**Creek Wearable Technology Co., Ltd.**

Ref: FCC Class II Permissive change for FCC ID: 2BBYH-C1023

This is to request a Class II Permissive change for FCC ID: 2BBYH-C1023 originally granted on 12/21/2023 (date).

Rear of Modified Heart  
Rate Monitor  
CW06  
HX3695S

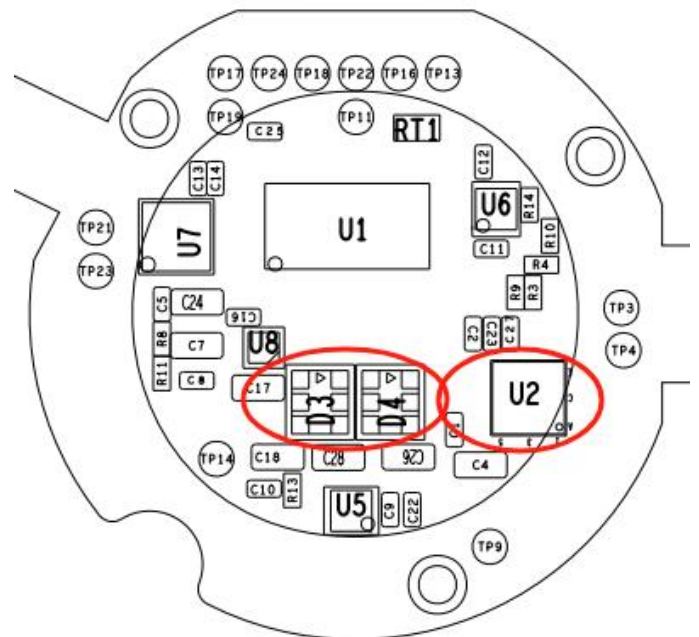
- 1, Heart rate board added material IC.HX3695S. Replace the original scheme IC.3690SI;
2. The heart rate board added D3 and D4 to replace the original U3;
